**Sandia Corporation
Albuquerque, New Mexico
December 15, 2006**

**DOE/Sandia Responses to NMED's
“Notice of Disapproval: Mixed Waste Landfill Corrective
Measures Implementation
Work Plan, November 2005”**

Comment Set 1

Figure 1 —iso-erodent map illustrating average annual values of the rainfall factor, R.

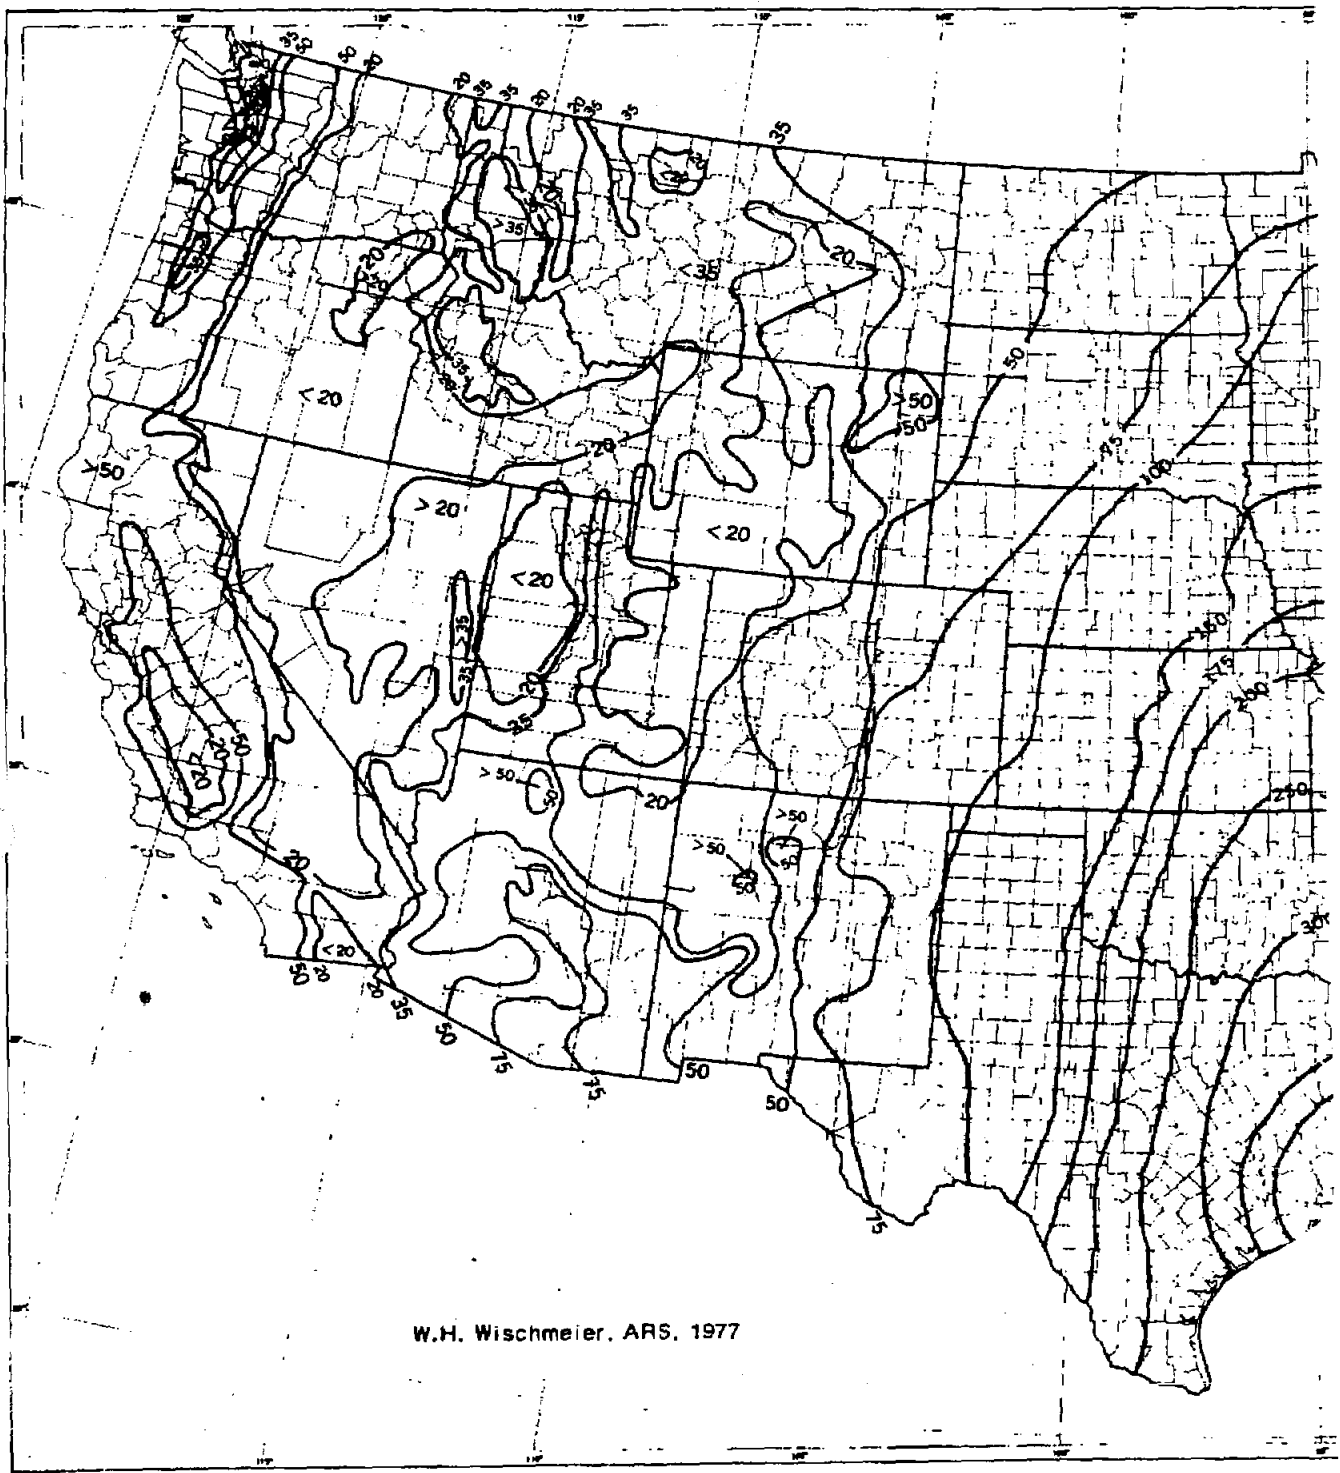
6. Section 5.7.1 -- Specify the values used for the variables R, K, LS, VM and sources of the values used in the MUSLE equation to predict soil loss by water erosion.

Parameter	Variable	Value	Additional Information
Rainfall Factor	R	35	Determined from isoerodent map of the western United States, illustrating average annual values of the rainfall factor, R. See Figure 1, Sheet 9 of Attachment 1.
Soil Erodibility Factor	K	0.44	Approximate value of K, based on a loamy very fine sand with organic content < 0.5%. See tabulation of AGRA test results, Table 1, Sheet 10 of Attachment 1; K determined from Table 2, Sheet 12, of Attachment 1.
Topographic Factor for Cover (2% slope)	LS	0.28	See Sheets 5 and 6 of Attachment 1.
Topographic Factor for Sideslope (16.7% slope)	LS	1.32	See Sheets 5 and 6 of Attachment 1.
Erosion Control Factor for Cover (no vegetation)	VM	0.06	Assumes no vegetation was yet established; that straw mulch had been applied to the cover and side-slopes at 2 tons/acre, and that the mulch was crimped into soils with a disk. See Sheet 7 and Sheet 14 of Attachment 1.

Figure 5. Unsheltered distance, L, for the 2% Cover Slope

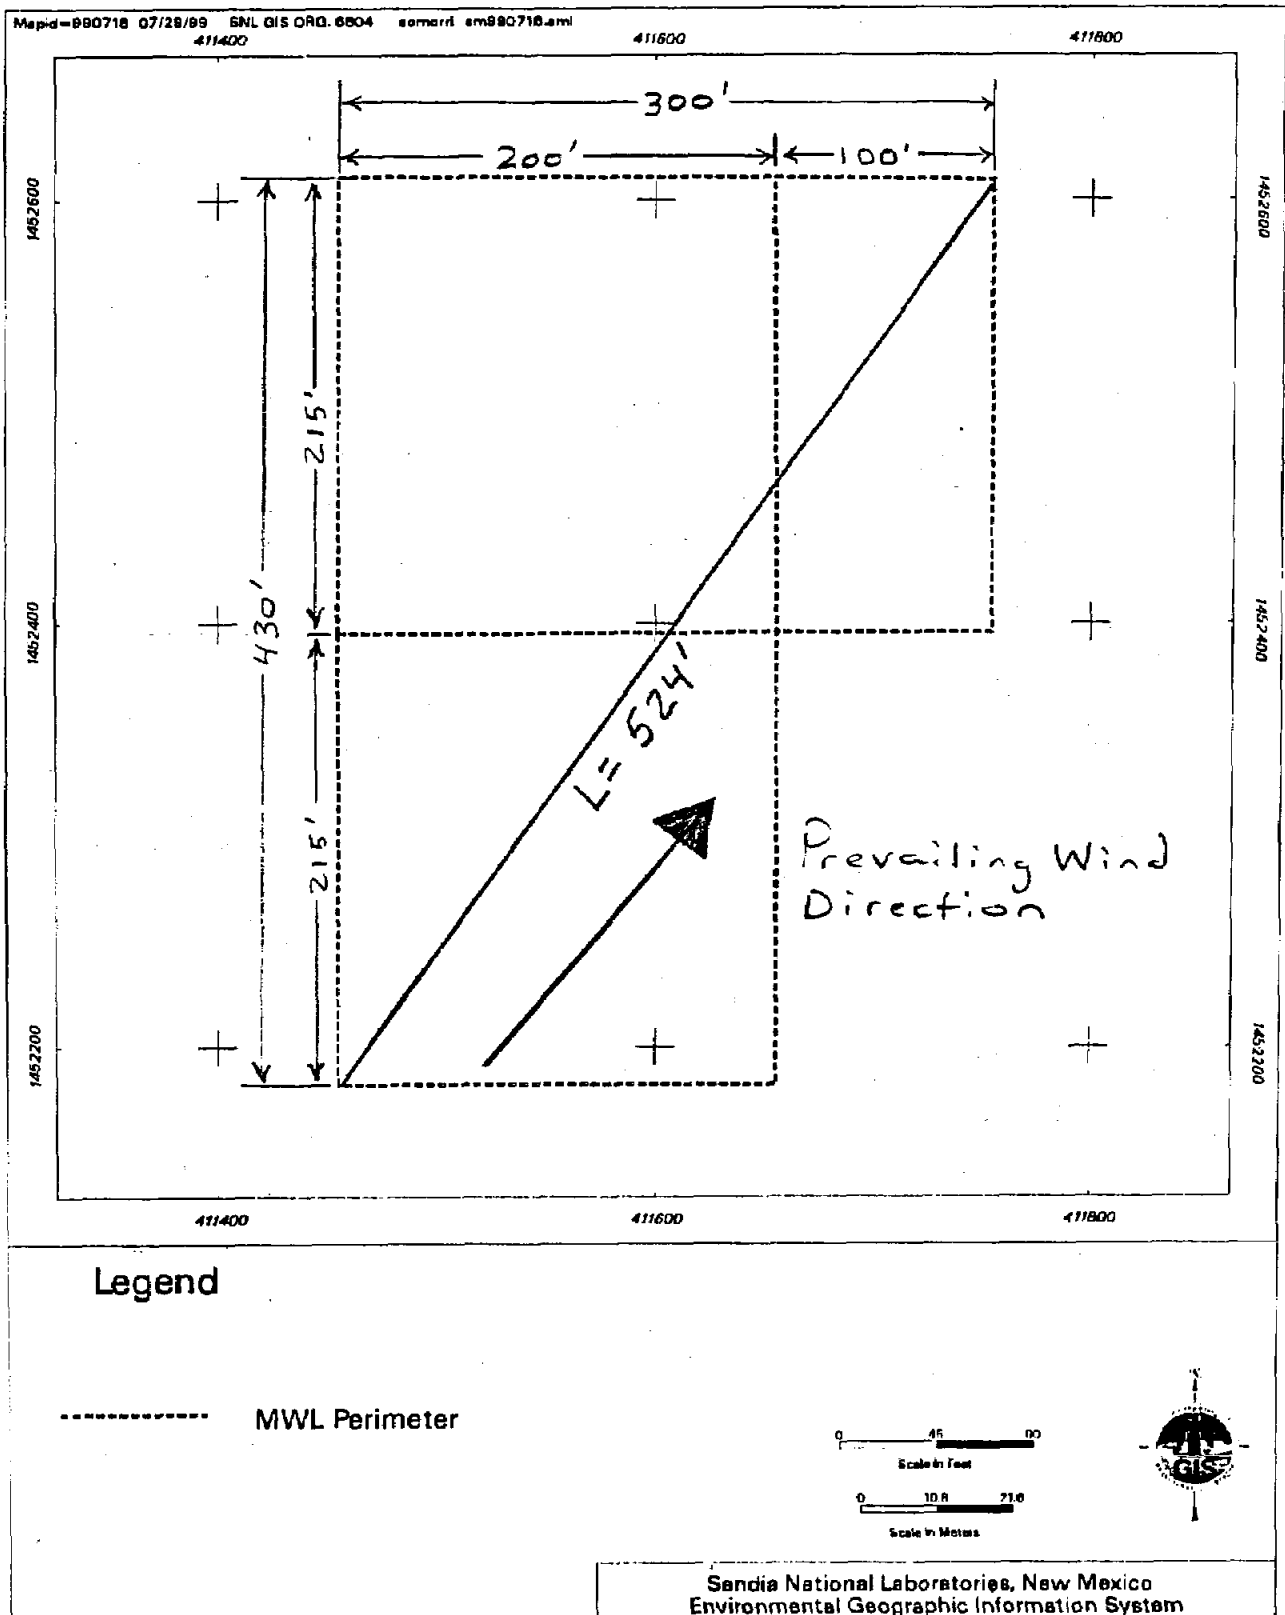
7. Section 5.7.2 -- Specify the values used for the variables I, k, C, L, V and sources of the values used in the WEQ equation to predict soil loss by wind erosion.

Parameter	Variable	Value	Additional Information
Soil Erodibility Index for Cover (2% slope)	I	134 tons/acre/year	Based on erodibility index for a loamy very fine sand, as determined by AGRA test results. See Sheet 2, 9 and 11 of Attachment 2.
Soil Erodibility Index for Sideslope (16.7% slope)	I	188 tons/acre/year	Based on erodibility index for a loamy very fine sand, as determined by AGRA test results. See Sheets 3, 9 and 11 of Attachment 2.
Total Surface Roughness (Cover and Sideslope)	k	1.0	Based on the assumption that the engineered cover and sideslopes will be smooth and without ridges. See Sheets 3, 4, 13 and 14 of Attachment 2.
Climatic Factor	C	120	Index of the relative erosivity by geographic location. See Sheets 5 and 15 in Attachment 2.
Unsheltered Distance (Cover)	L	524 ft	Field length along the prevailing wind direction. See Sheets 5 and 15 of Attachment 2.
Unsheltered Distance (Sideslope)	L	25 ft	Field length along the prevailing wind direction. See Sheets 5 and 15 of Attachment 2.

EXHIBIT 1

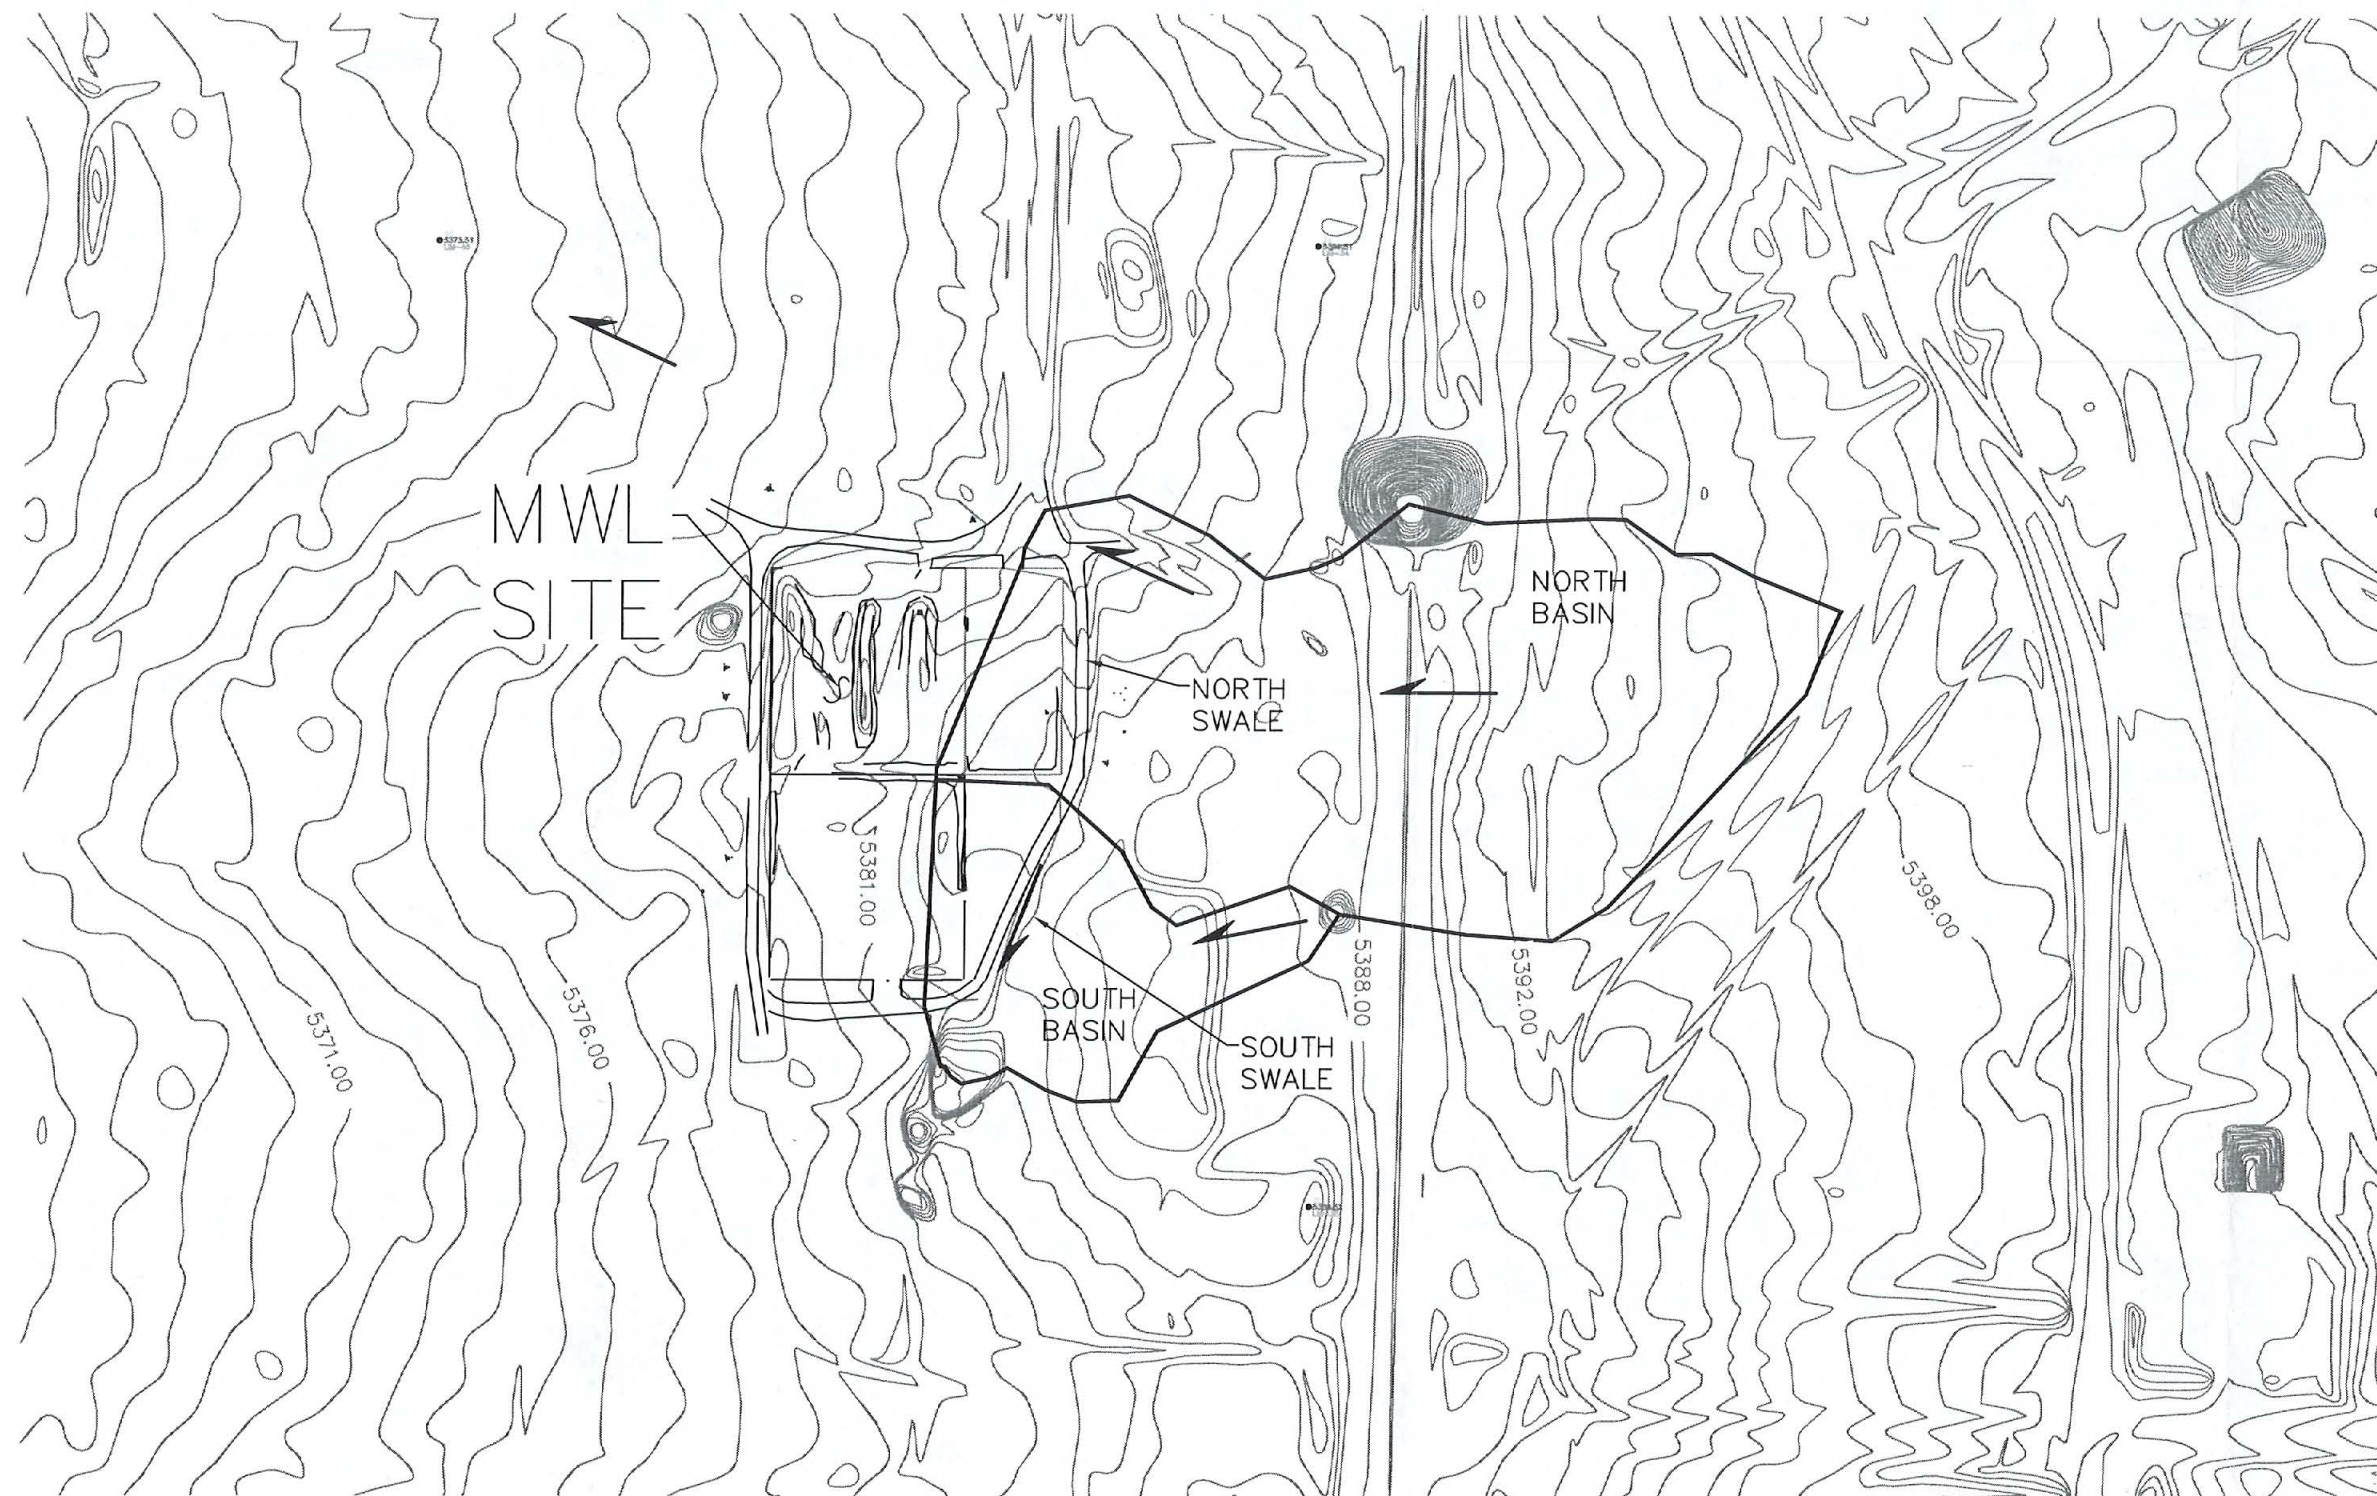
16. Demonstrate with calculations and other information whether run-off and run-on controls have been adequately designed to handle peak precipitation events. Evaluate and discuss whether additional run-on controls should be constructed at locations further away from the landfill (e.g., at distances of 25 to 50 meters) to provide more protection for the cover from heavy rainfall events.

The site will be graded such that runoff from the site flows north, west and east. There is a high point on the north side of the site that prevents flow from running onto the site. Two swales will be provided to carry the flow to the north or the south. This may be seen in Exhibit 1: Mixed Waste Landfill Final Cover Grading Plan”, included in the complete

The site will be graded such that runoff from the site flows north, west and east. There is a high point on the north side of the site that prevents flow from running onto the site. Two swales will be provided to carry the flow to the north or the south. This may be seen in Exhibit 1: Mixed Waste Landfill Final Cover Grading Plan" attached.
